Westinghouse
Electric Corporation

NSD-NRC-96-4732
DCP/NRC0522
Docket No.: STN-52-003

SUBJECT: DESIGN INFORMATION ON SHIELD BUILDING ROOF

References: 1) NRC letter from Diane Jackson, dated 3/21/96, "Summary of Meeting to Discuss Westinghouse AP600 Shield Building Roof Structures".

Figure 2.3.11 POSITIVE SIGN CONVENTION FOR INTERPRETING RESULTS OF PLANE STRESS/STRAIN AND PLATE BENDING ELEMENTS

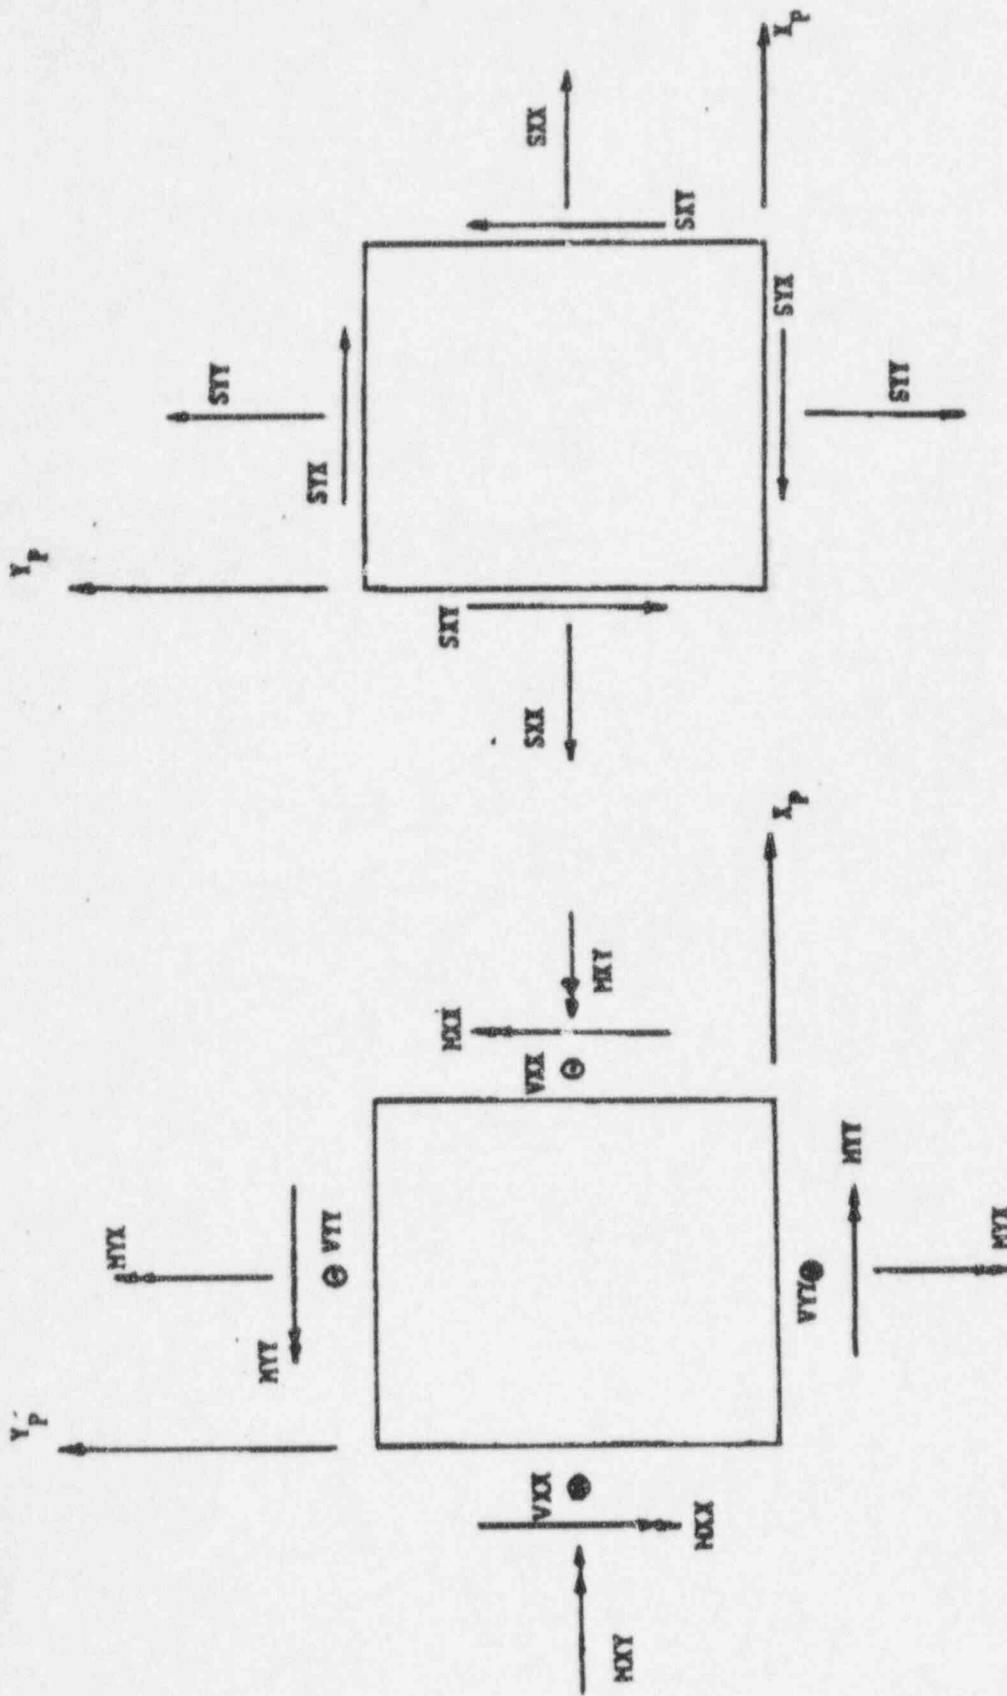
2. What is the correspondence between the numbered sections in the shield building roof section illustrated in Attachment 2 of the NRC meeting summary dated March 21 and the sections in the ANSALDO analysis Tables 72 to 76 in the Westinghouse presentation material?

Member forces are reported in the meeting handout at the nodes (sections) shown in the figure. These results at the node are averaged with respect to the elements interfacing at the node, as described in attachment 1 taken from the GTSTRUDL users manual.

SHIELD BUILDING ROOF
FOOTPRINT DEAD AND SEISMIC LOADS

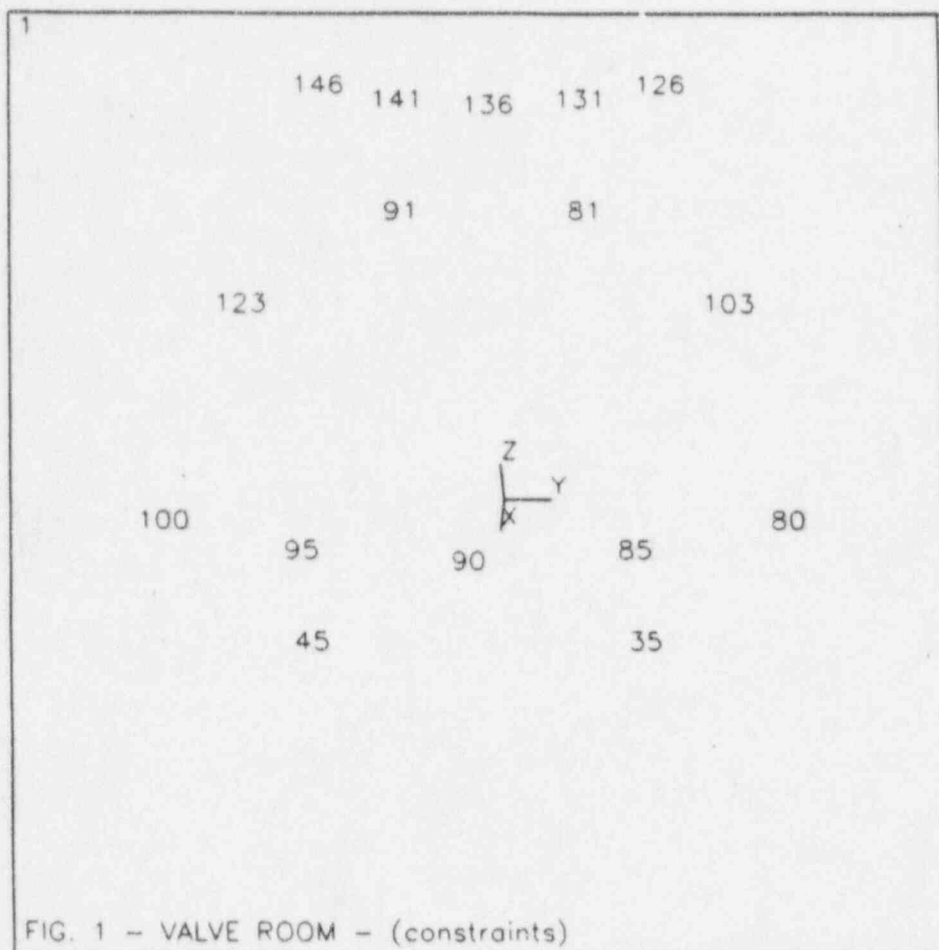
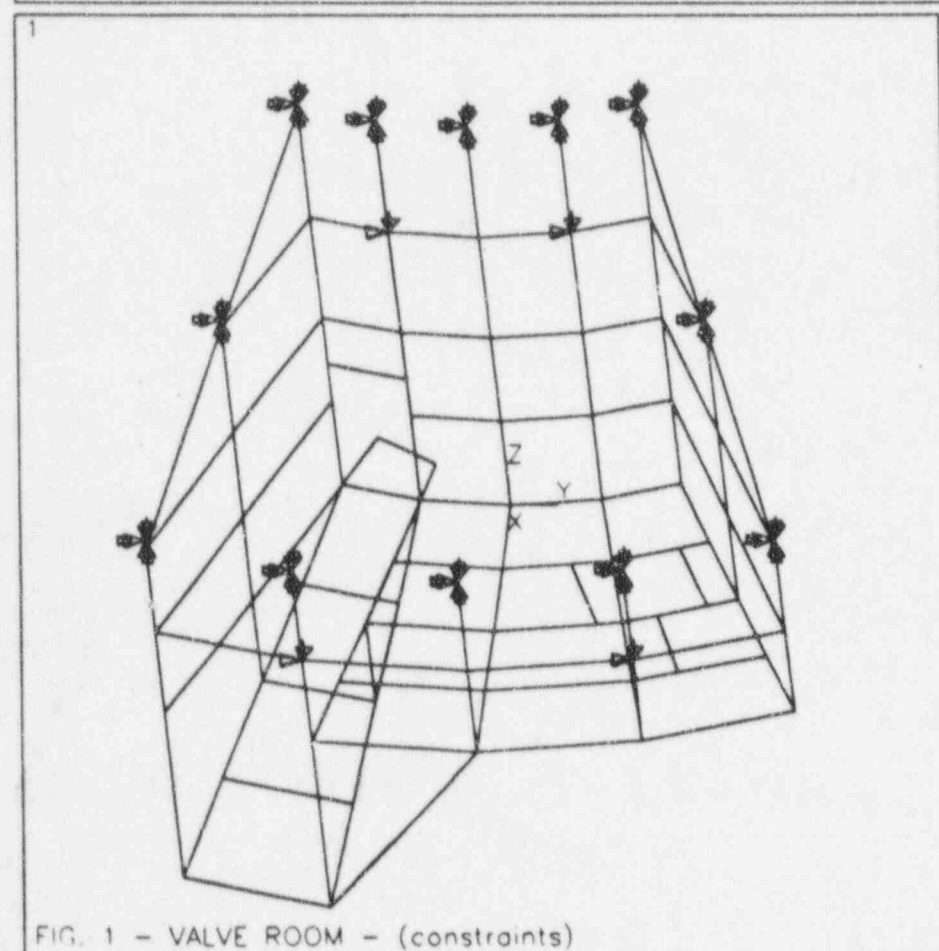
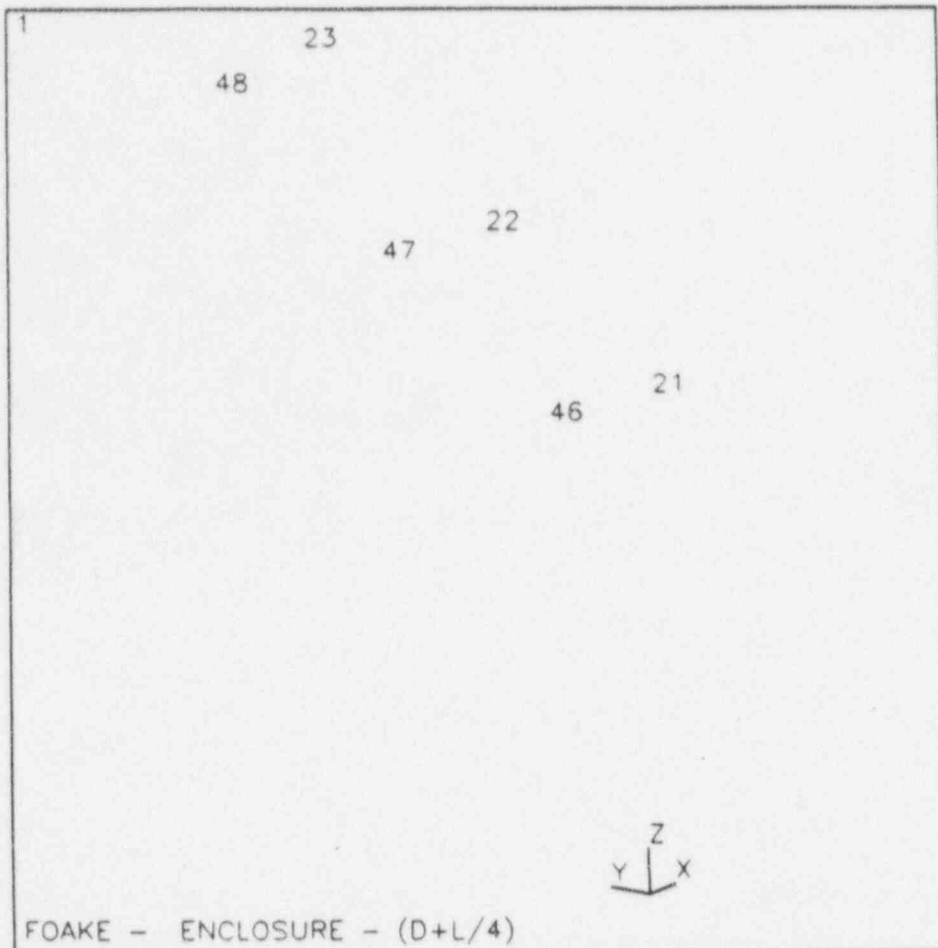
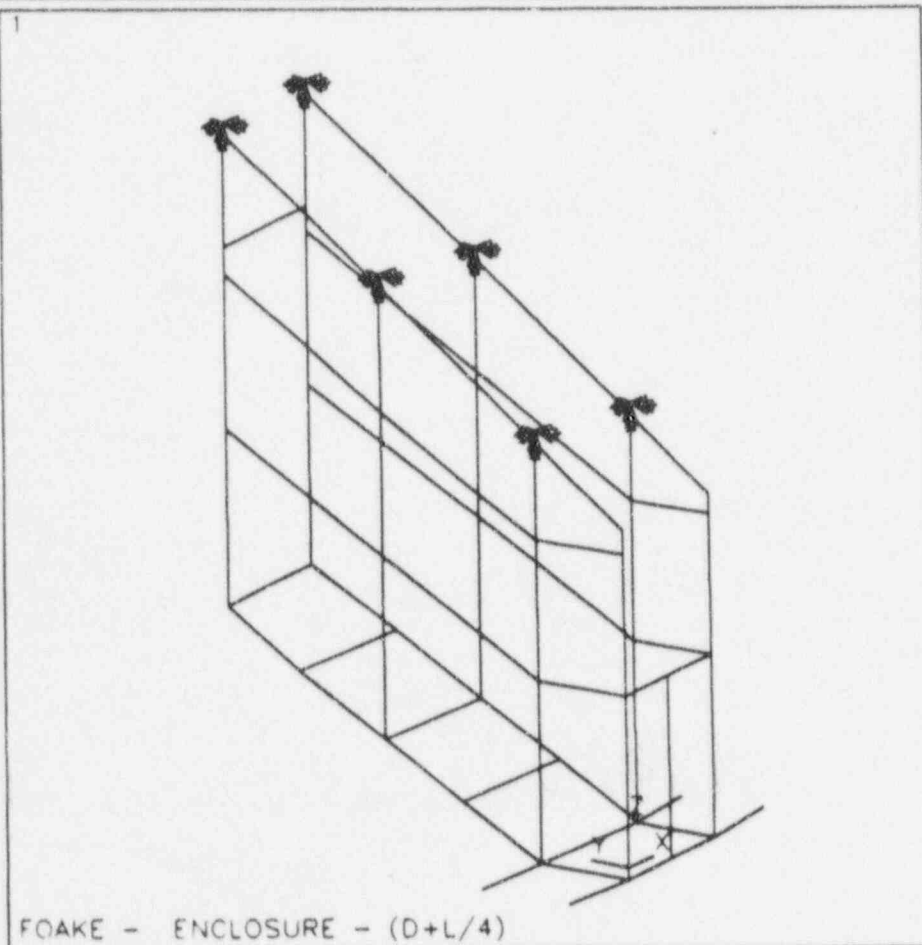
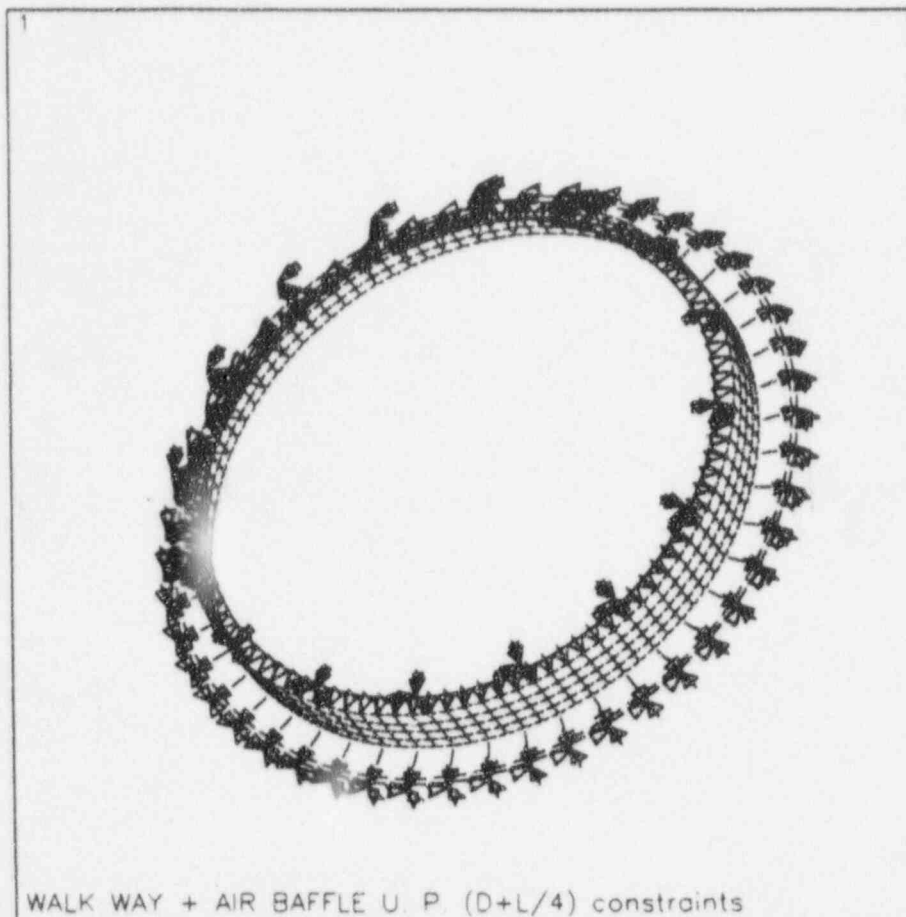
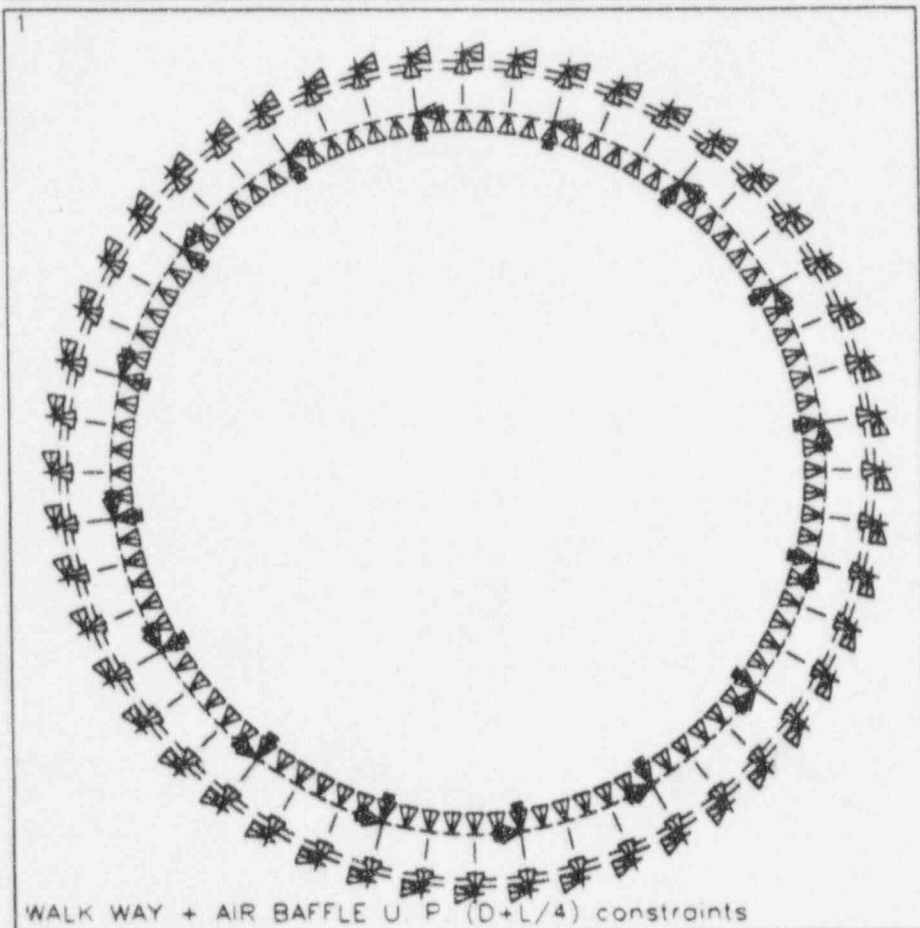
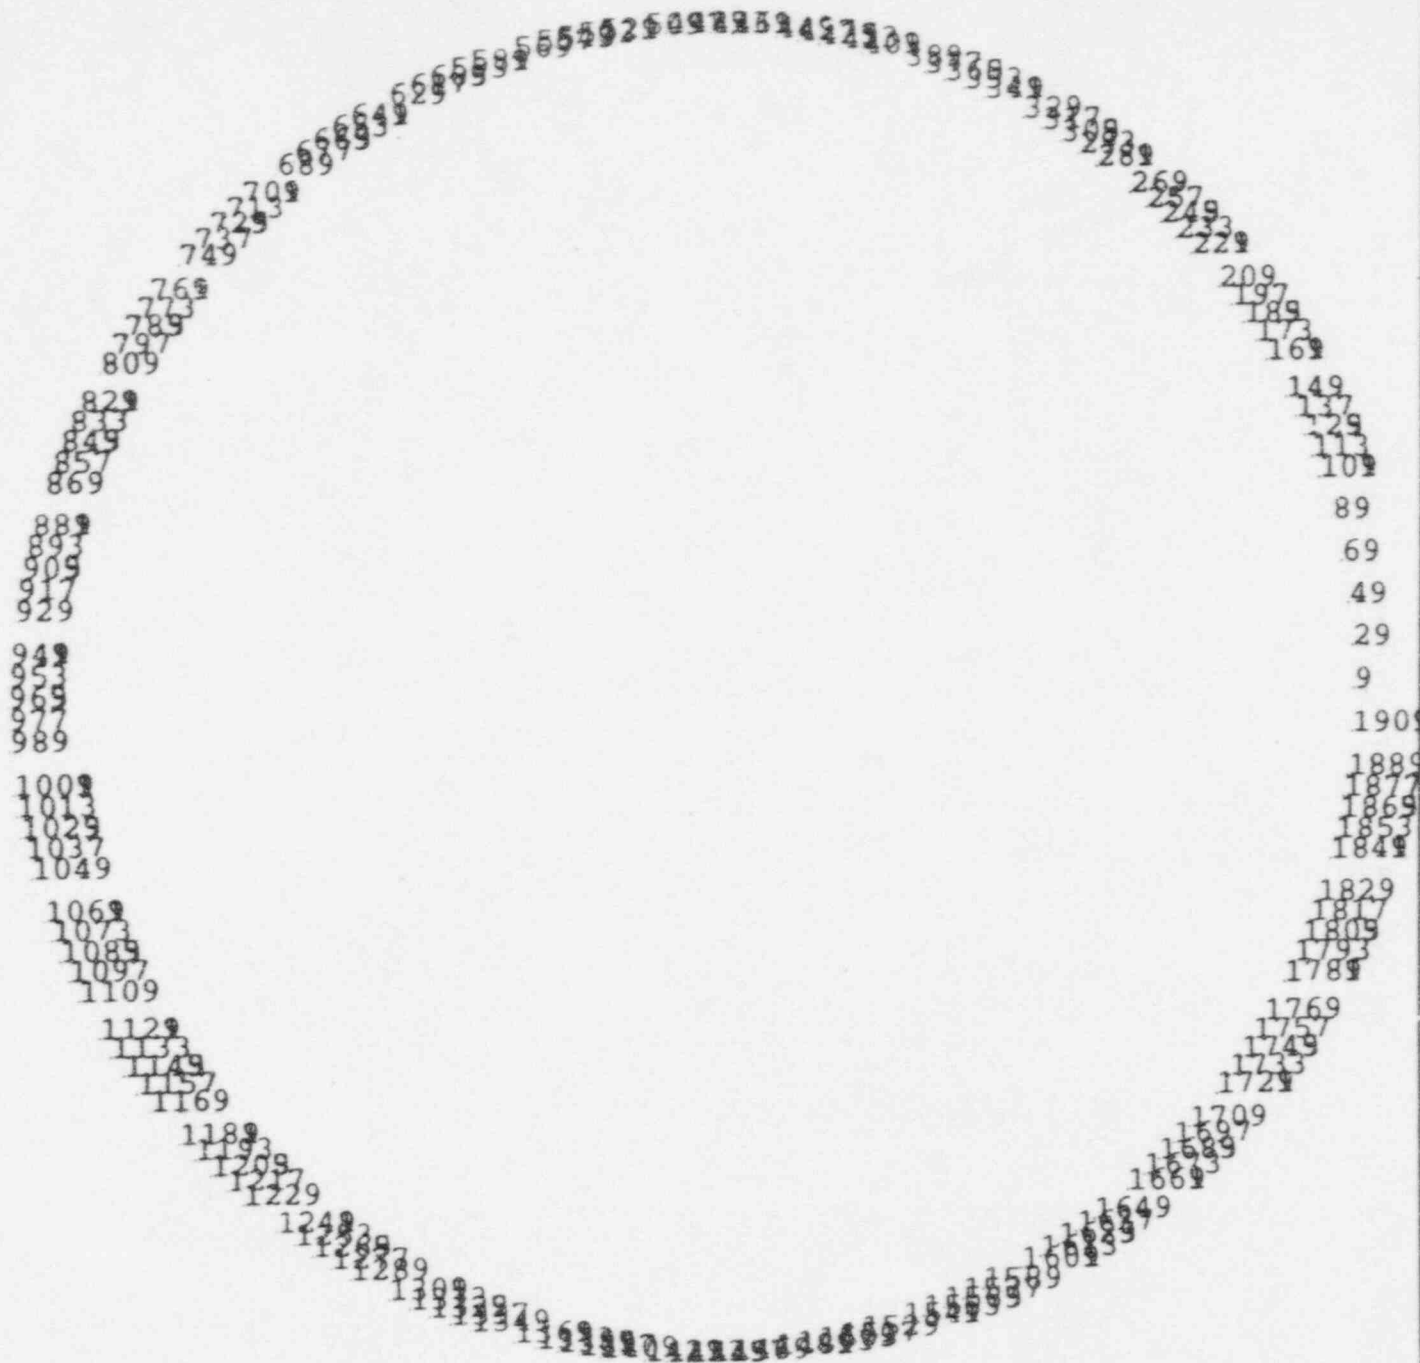
3. What are the masses of the passive containment cooling system (PCS) valve room and stair enclosure and their center of gravity locations?

Attachment 2 provides dead and seismic reactions for the valve room (pages 1-4), stair enclosure (pages 5-8) and air baffle upper ring (pages 9-32). For each structure, the attachment includes a figure showing the location of support points, a table of the support coordinates, and tables of dead and seismic reactions. For the air baffle upper support ring reactions are given in both the global coordinate system as well as in cylindrical coordinates.

Coupled Auxiliary & Shield Buildings
Location of Seismic Responses @ Elevation 180'-0"

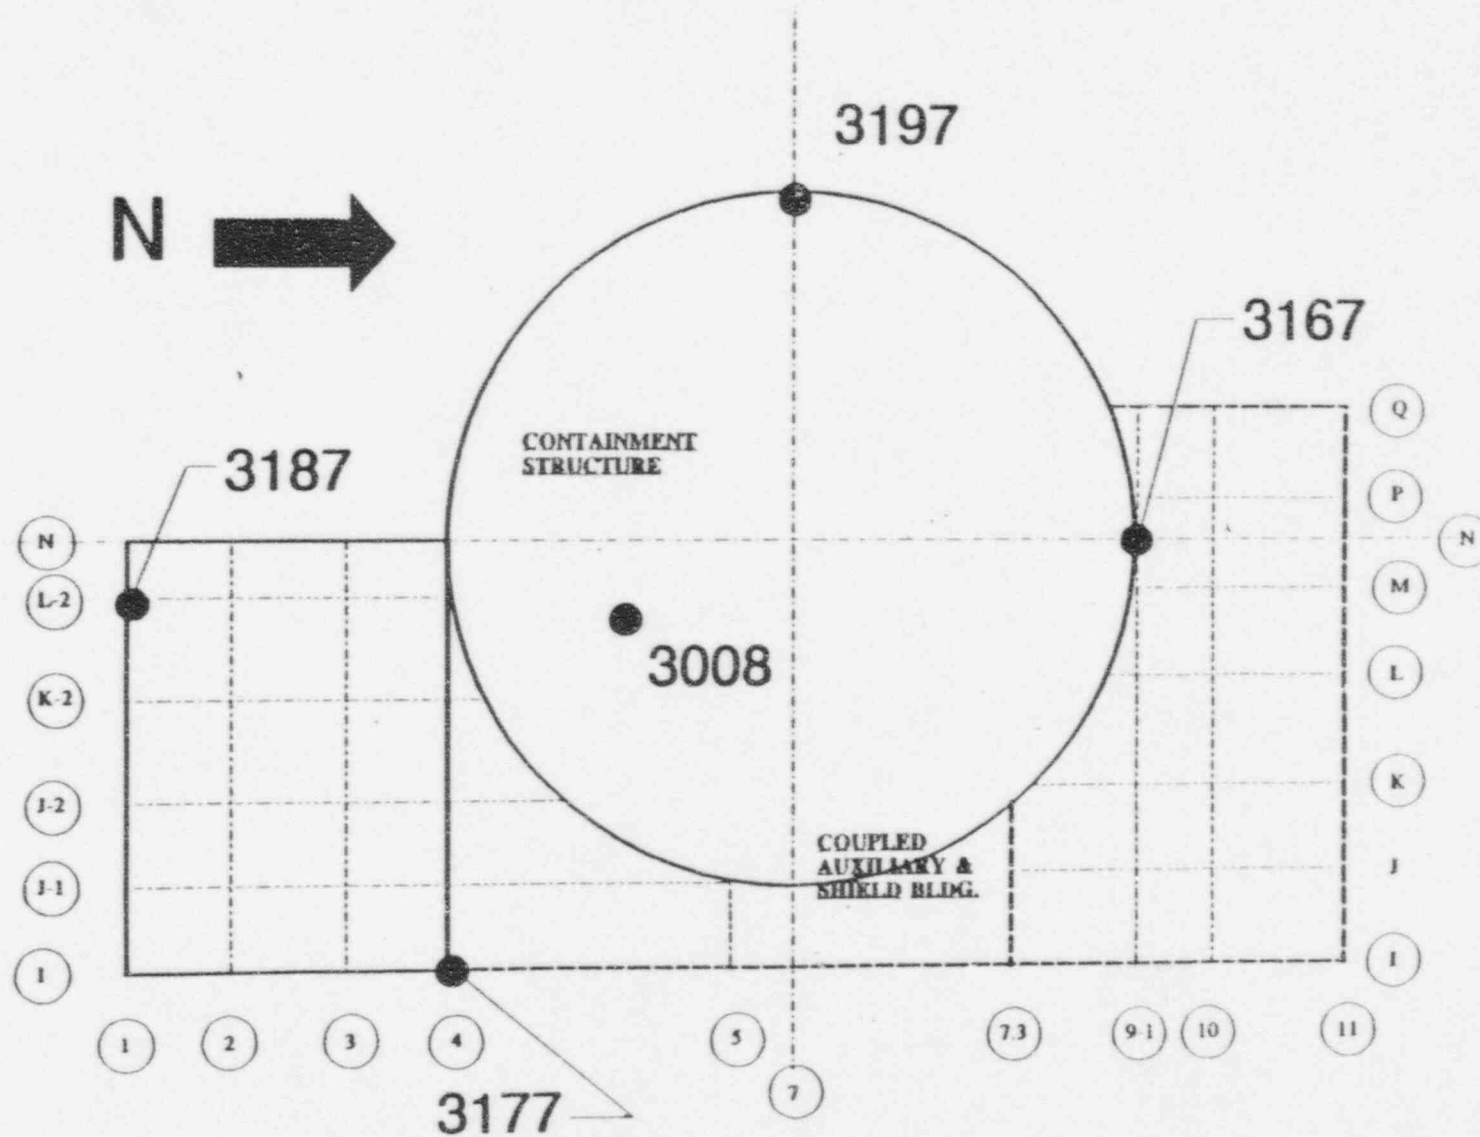
4. Provide the loads for the shield building roof structure including the digitized six-degrees-of-freedom (three translational and three rotational) raw (without peak broadening) floor response spectra at elevation 180 ft. corresponding to all design site conditions for the input loads of the staff's confirmatory analysis.

- a) Design loads are given in Attachment 3. Hydrostatic loads are defined in Appendix 1, snow loads in Appendix 2, wind loads in Appendix 3, and thermal loads in Appendix 5.
- b) Attachment 4 provides the following seismic inputs:
 - o The raw response spectra for the four design soil cases and the enveloped and widened response spectra at nodes 3008, 3167, and 3197.
 - o Figure showing the location of the nodes. Node 3008 is at the center of mass and nodes 3167 and 3197 are at the north and west edges, respectively.
 - o An explanation of the response spectra files represented by the hard copies of the spectra.
 - o A listing of the response spectra electronic files.

Response spectra are provided for 2, 3, 4, 5, 7, 10 and 20 percent damping. Response spectra for 0.5 percent are not available. Rotational time histories are not available, but the magnitude of rocking can be estimated from the difference in vertical responses at the center of mass and edge nodes.
